**Re: DOCKET NO. 503 – Arx Wireless Infrastructure, LLC application for a Certificate of Environmental Compatibility and Public Need for the construction, maintenance and operation of a telecommunications facility located at 43 Osgood Avenue, New Britain, Connecticut**

**New Cingular Wireless PCS LLC's (AT&T) Response to Interrogatories**

**RESPONSES OF INTERVENOR NEW CINGULAR WIRELESS PCS, LLC  
d/b/a AT&T TO CONNECTICUT SITING COUNCIL PRE-HEARING  
INTERROGATORIES**

REV 0

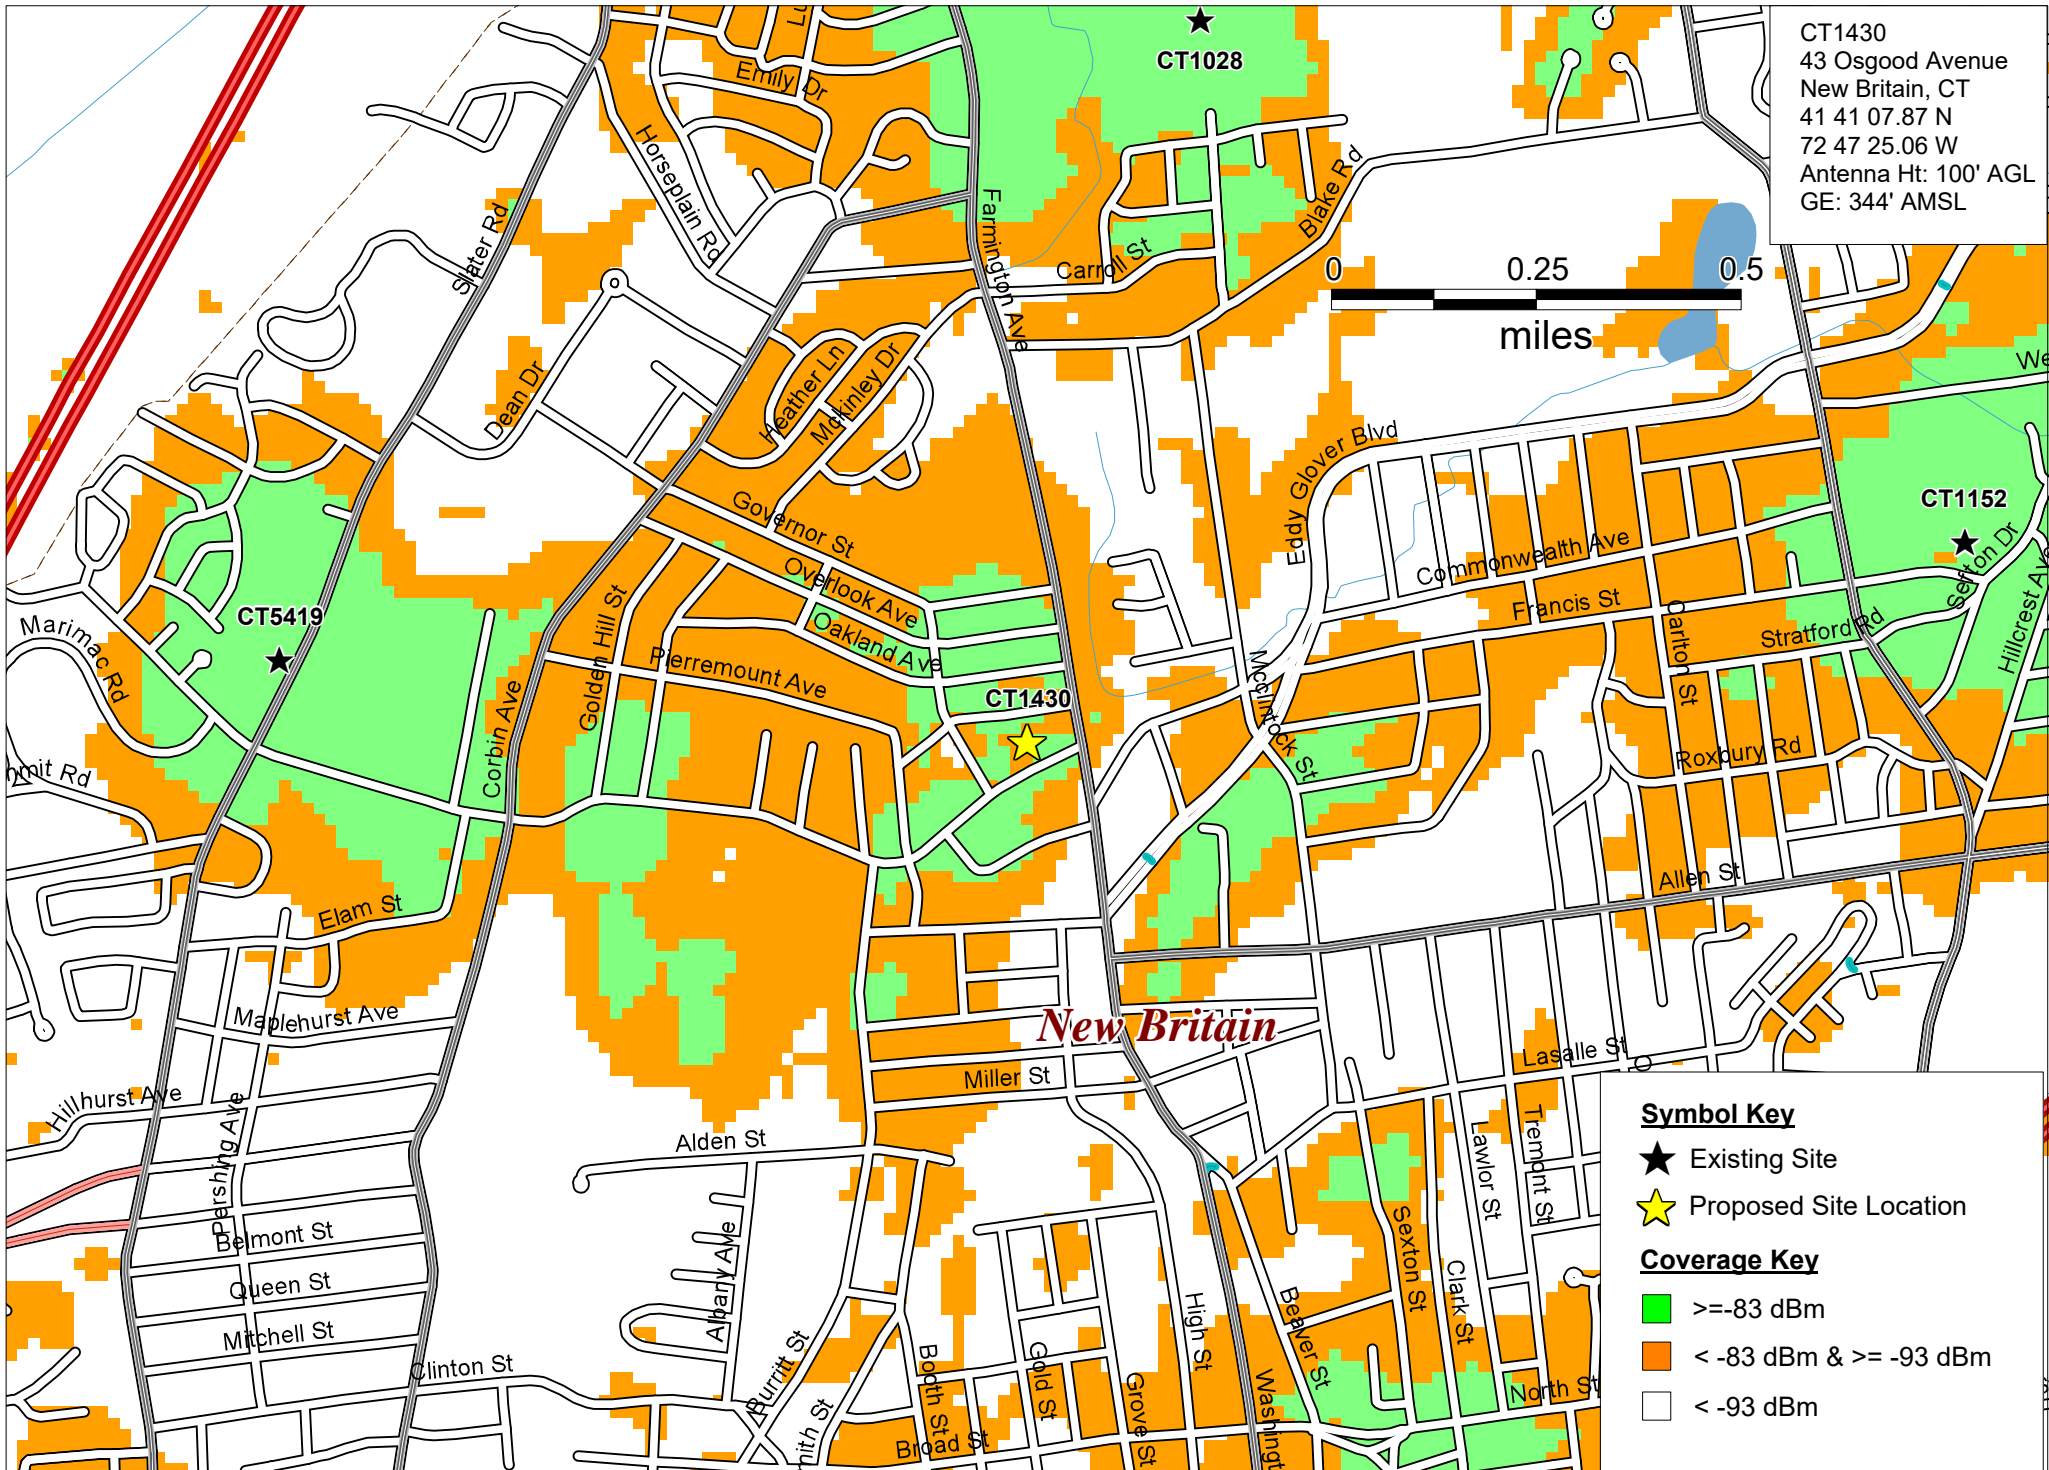
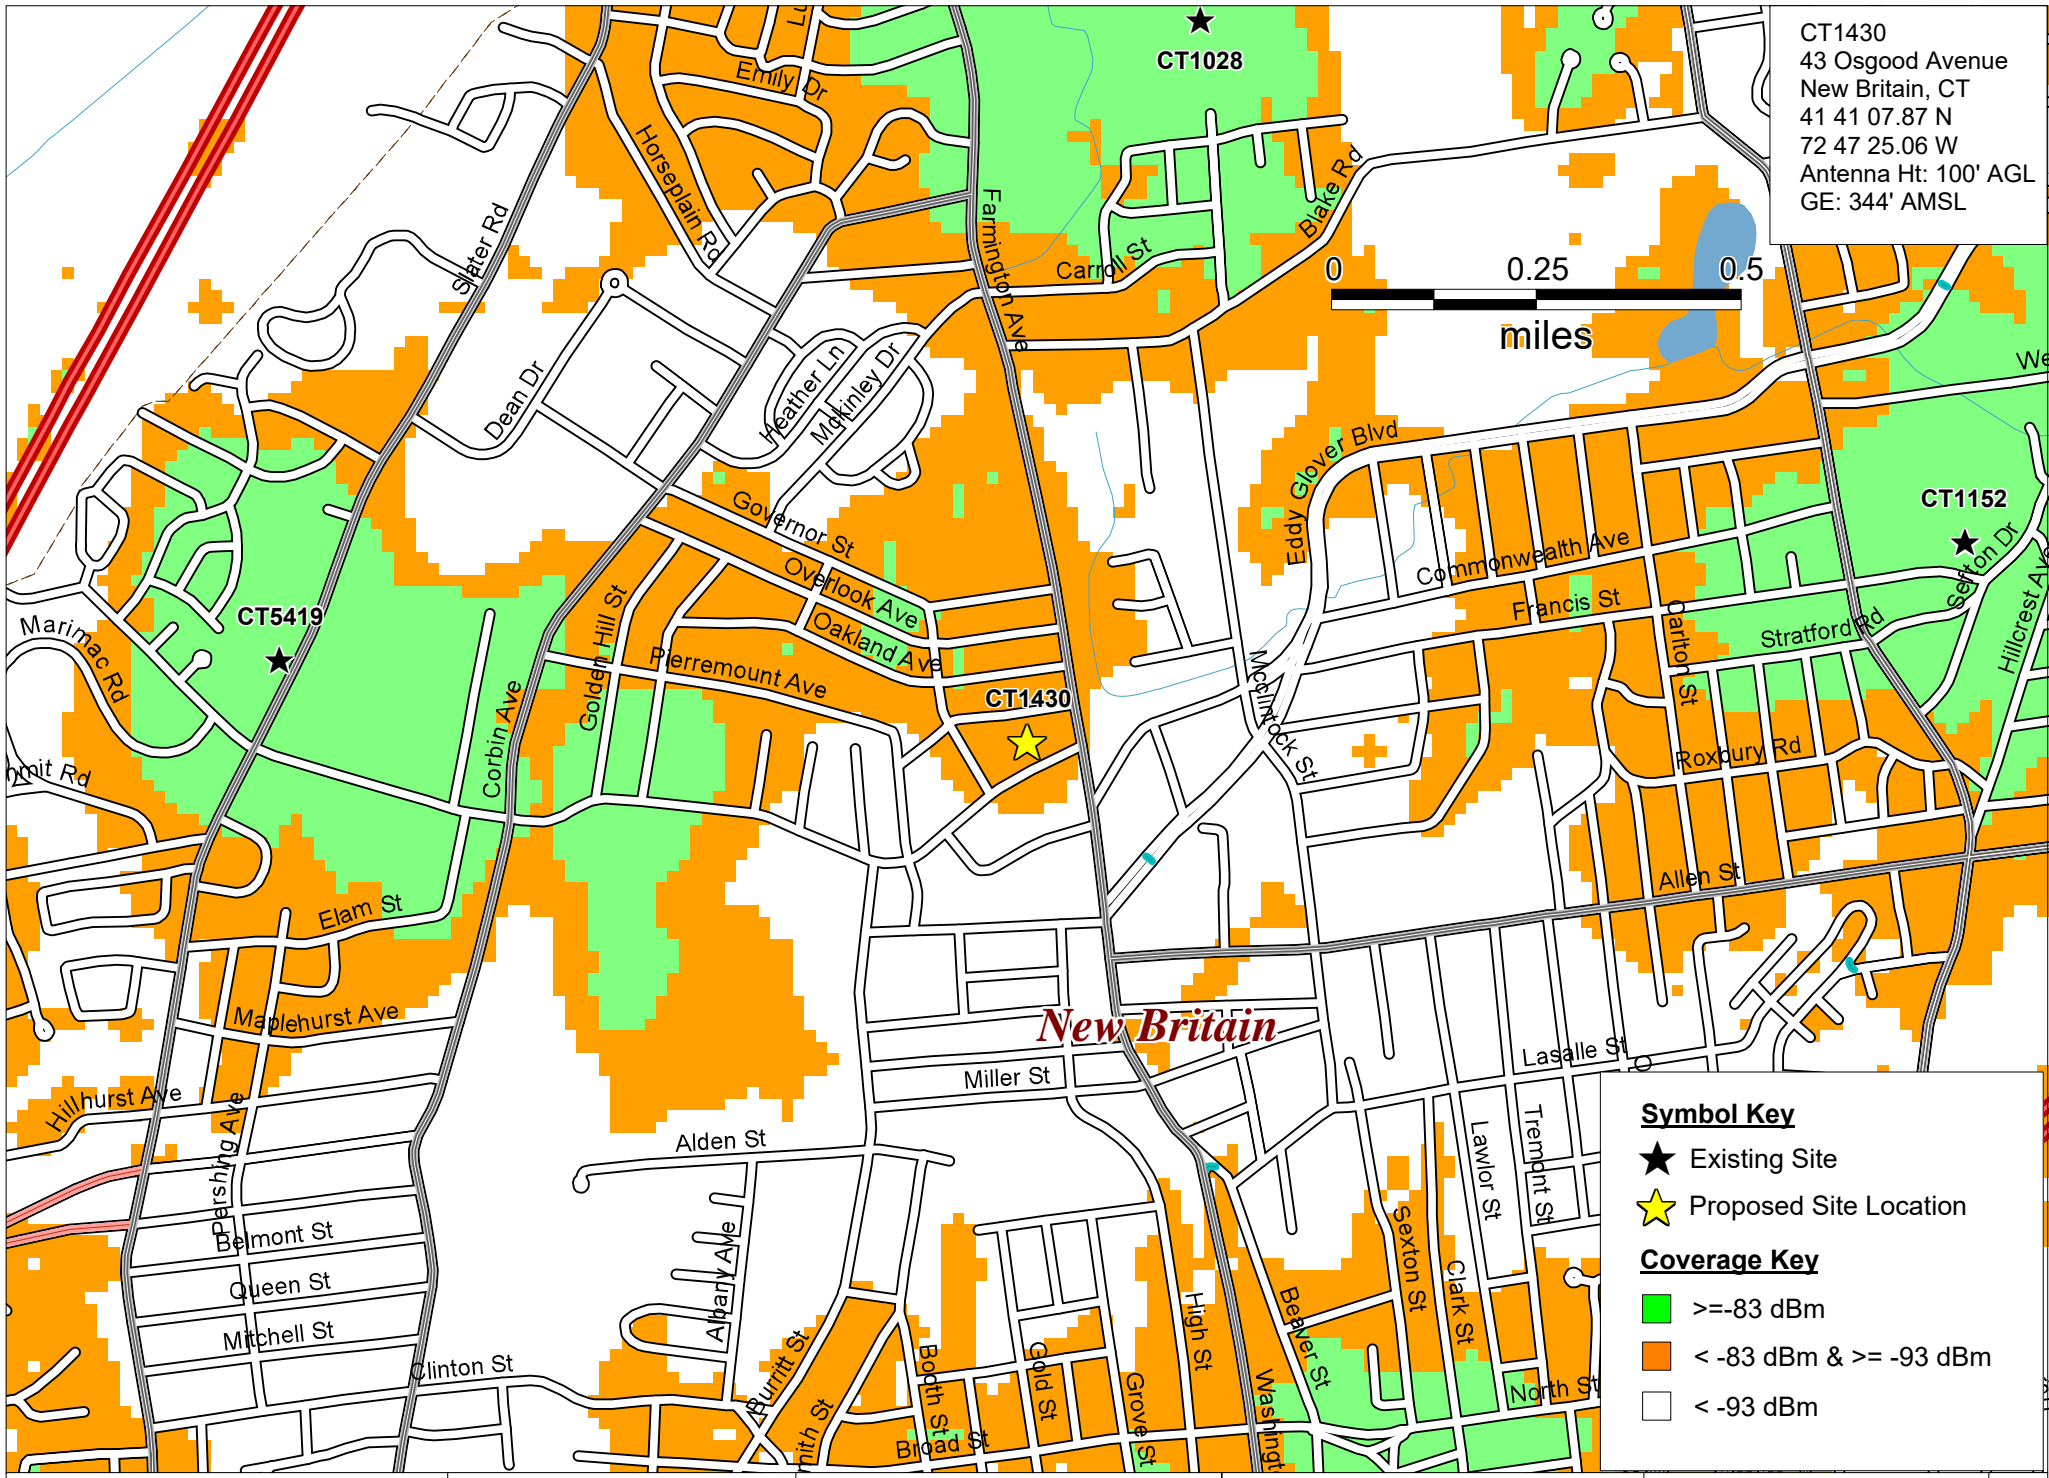
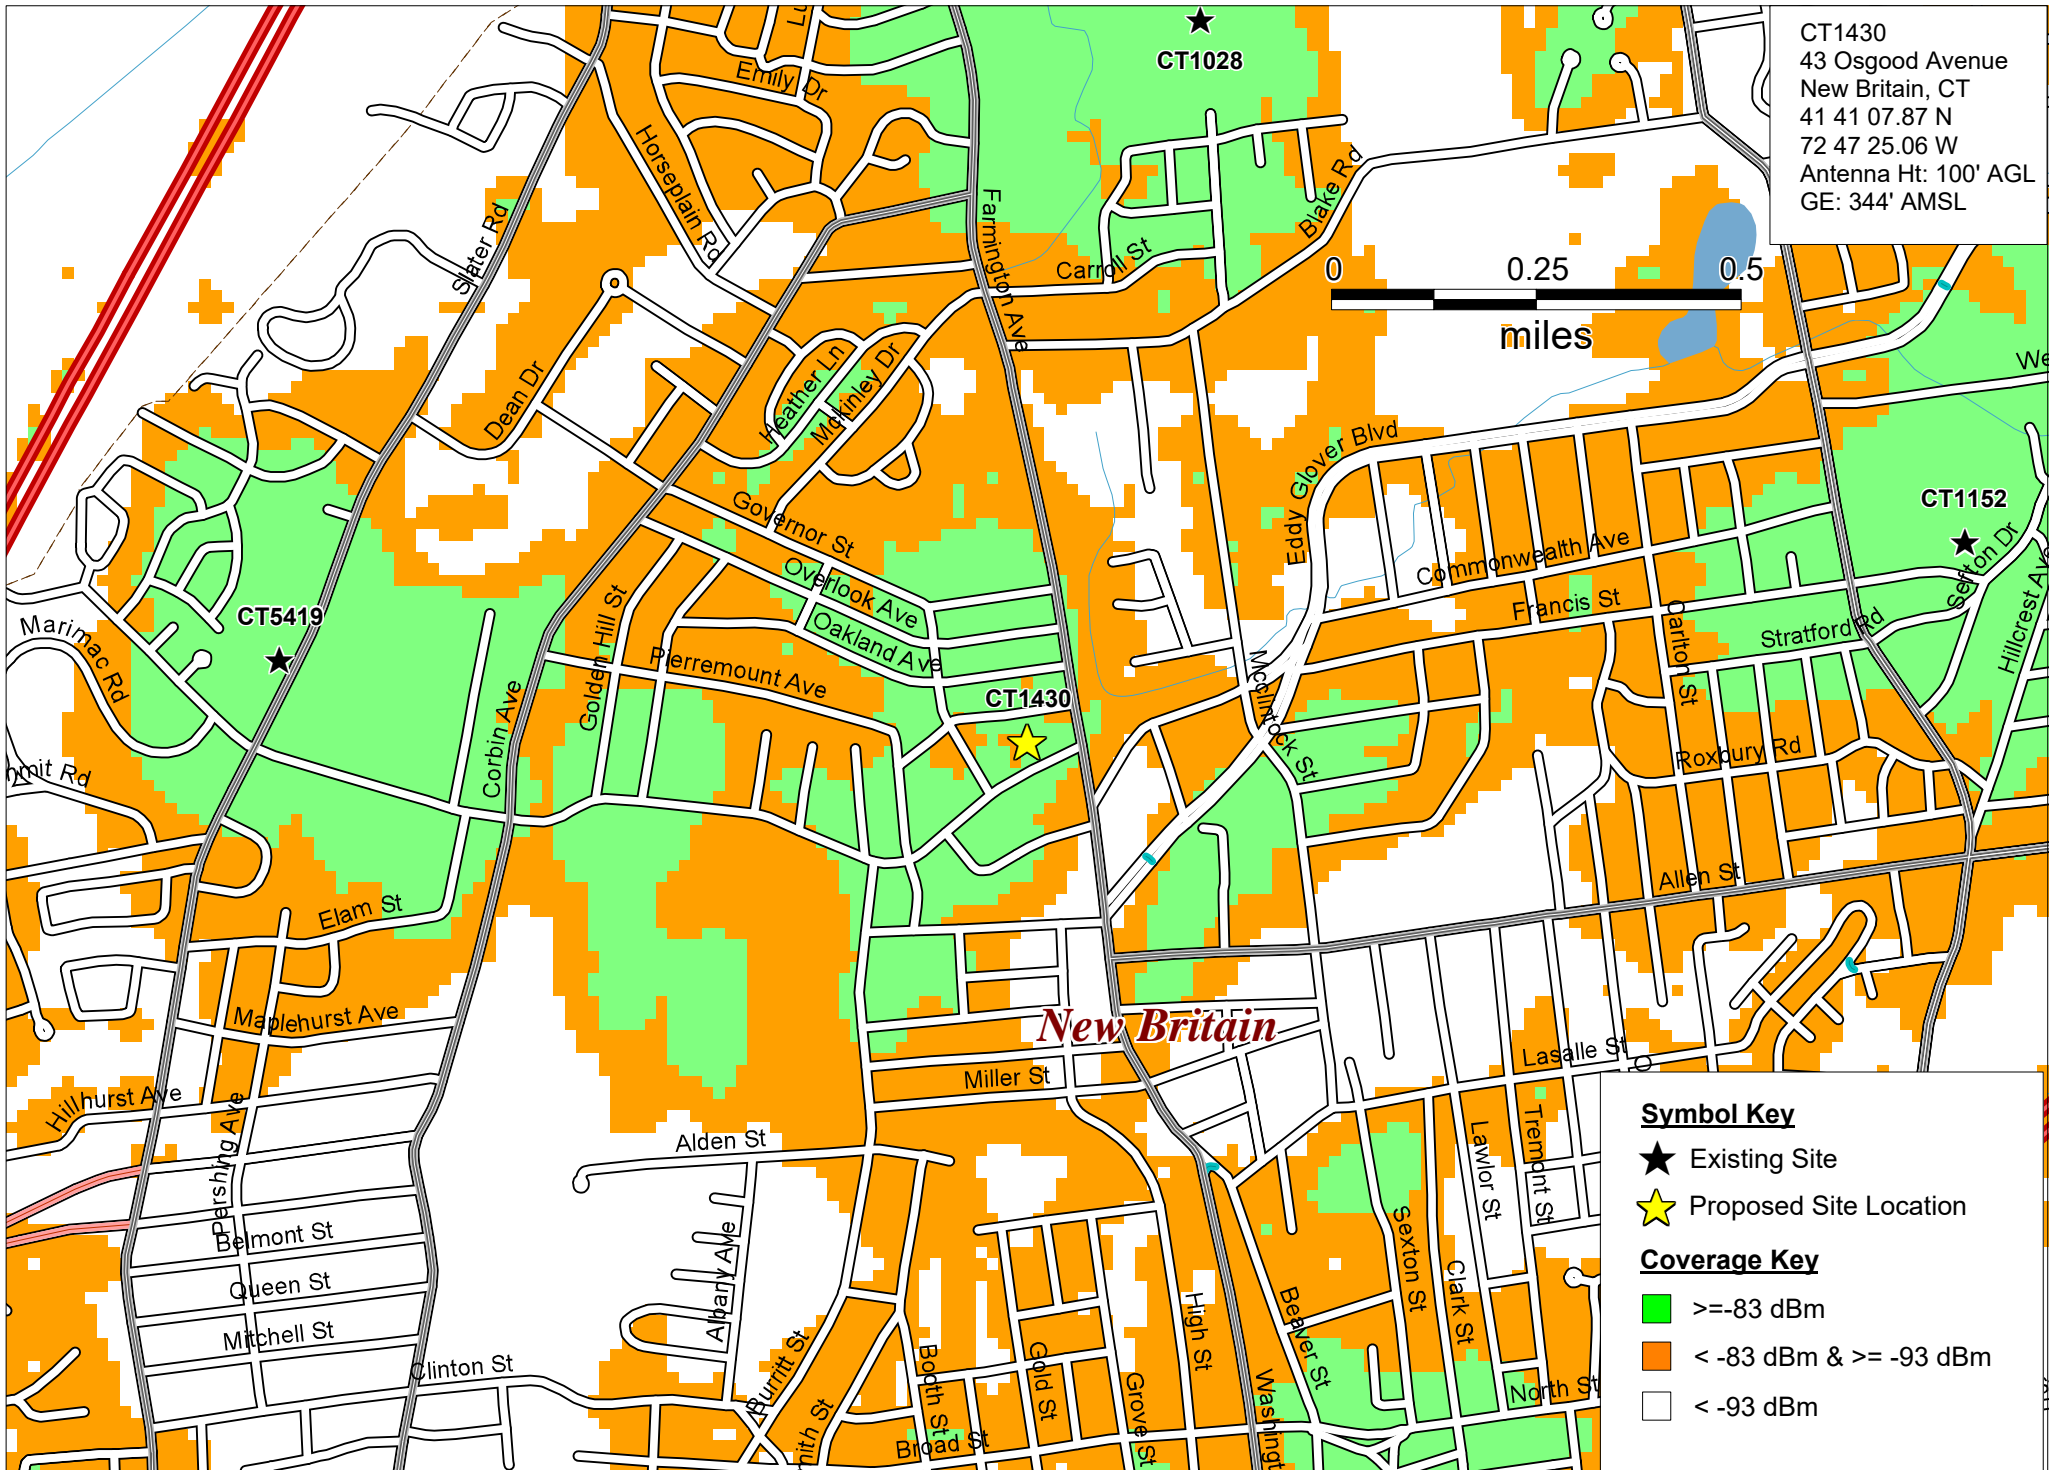
Q8. Provide existing coverage plots for each frequency band to be deployed by AT&T at the site. Provide a similar set of plots for each frequency band that include existing plus proposed coverage.

A8. *Please see the coverage plot included in Attachment A.*
